Project	IEEE 802.16 Broadband Wireless Access Working Group < http://ieee802.org/16 >	
Title	Comment on duration of subframe in DL-MAP/UL-MAP	
Date Submitted	2008-07-07	
Source(s)	Kanchei(Ken) Loa, Yi-Hsueh Tsai, Yung-Ting Lee, Hua-Chiang Yin, Youn-Tai Lee Institute for Information Industry (III) Shiann-Tsong Sheu National Central University (NCU) Yang-Han Lee, Yih-Guang Jan Tamkang University (TKU)	Voice: +886-2-66000100 Fax: +886-2-66061007 loa@iii.org.tw stsheu@ce.ncu.edu.tw yhlee@ee.tku.edu.tw
Re:	IEEE 802.16-08/028: "IEEE 802.16 Working Group Letter Ballot Recirc #28d: Announcement"	
Abstract	Comment on duration of subframe in DL-MAP/UL-MAP	
Purpose	Text proposal for 802.16j Draft Document.	
Notice	<i>This document does not represent the agreed views of the IEEE 802.16 Working Group or any of its subgroups. It represents only the views of the participants listed in the "Source(s)" field above. It is offered as a basis for discussion. It is not binding on the contributor(s), who reserve(s) the right to add, amend or withdraw material contained herein.</i>

Comment on duration of subframe in DL-MAP/UL-MAP

Figure 1 Current scenario

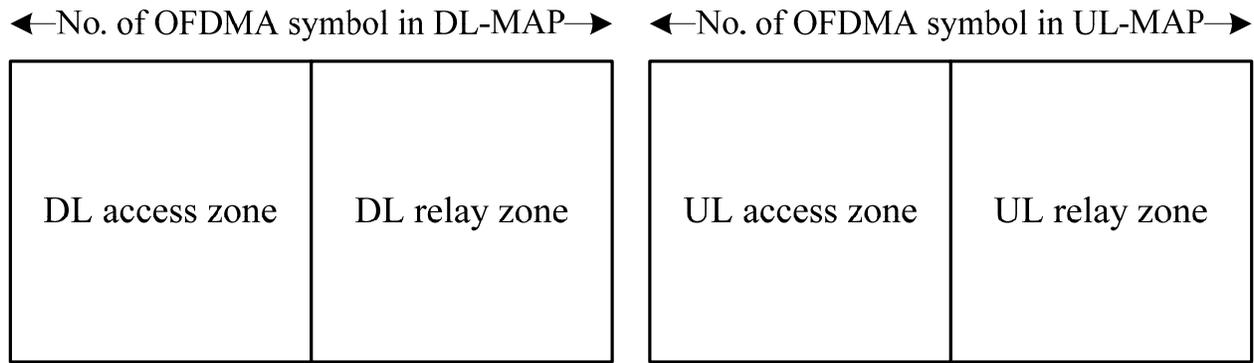
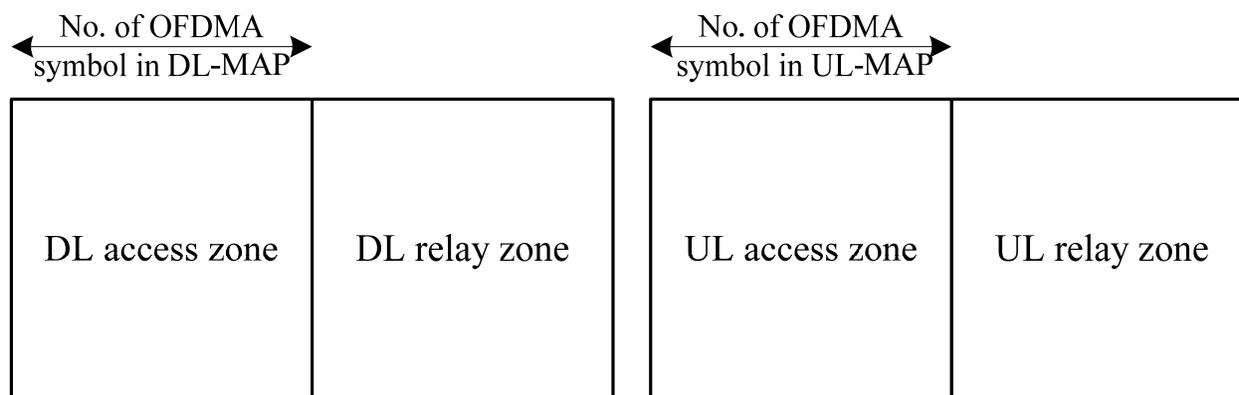
In P802.16j/D5, it may divide the downlink (uplink) subframe into one access zone following by relay zones for multi-hop relay operation. For non-transparent MR systems, the DL-MAP (UL-MAP) only describes the radio resource allocations in the access zone, but the number of OFDMA symbols of the downlink (uplink) subframe described in the DL-MAP (UL-MAP) includes both access and relay zones, i.e., the entire downlink (uplink) subframe. In order to avoid MS communicating with MR-BS in the downlink (uplink) relay zone, an extra GAP (Safety) zone IE must be used in DL-MAP (UL-MAP). (see Figure 1)

To reduce MAP overhead in the access zone and eliminate the dependency of the GAP (Safety) zone IE, we propose to change “*the number of OFDMA symbols in the downlink (uplink) subframe*” of the DL-MAP (UL-MAP) to only include the downlink (uplink) access zone. Thus the GAP (Safety) zone IE for describing the downlink (uplink) relay zone in DL- MAP (UL- MAP) could be omitted.

[Modify the following text in line 59 of page 26 as indicated:]

Syntax	Size (bit)	Notes
DL-MAP_Message_Format() {	-	-
Management Message Type = 2	8	-
PHY Synchronization Field	<i>variable</i>	See appropriate PHY specification.
DCD Count	8	-
Base Station ID	48	-
Begin PHY-specific section {	-	See applicable PHY subclause.
if (WirelessMAN-OFDMA) {	-	-
No. OFDMA symbols	8	For TDD, the number of OFDMA symbols in the DL subframe including all AAS/permutation zone and including the preamble. <u>(it may exclude the relay zones)</u> For FDD, see section 8.4.4.1.2
}	-	-
for ($i = 1; i \leq n; i++$) {	-	For each DL-MAP element 1 to n .
DL-MAP_IE()	<i>variable</i>	See corresponding PHY specification.
}	-	-
}	-	-
if !(byte boundary) {	-	-
Padding Nibble	4	Padding to reach byte boundary.
}	-	-
}	-	-

Management Message Type = 3	8	-
FDD Partition Change Flag	1	For FDD only. Indicates the next possible partition change. 0b0:Possible partition change in next frame 0b1:Minimum number of frames (excluding current frame) before next possible change is given by TLV 'FDD frame partition change timer'
<i>Reserved</i>	7	Shall be set to zero.
UCD Count	8	
Allocation Start Time	32	
Begin PHY-specific section {	-	See applicable PHY subclause.
if (WirelessMAN-OFDMA) {	-	-
No. OFDMA symbols	8	For TDD, the number of OFDMA symbols in the UL subframe. <u>(it may exclude the relay zones)</u> For FDD, see Section 8.4.4.1.2
}	-	-
for ($i = 1; i \leq n; i++$) {	-	For each UL-MAP element 1 to n .
UL-MAP_IE()	<i>variable</i>	See corresponding PHY specification.
}	-	-
}	-	-
if !(byte boundary) {	-	-
Padding Nibble	4	Padding to reach byte boundary.
}	-	-
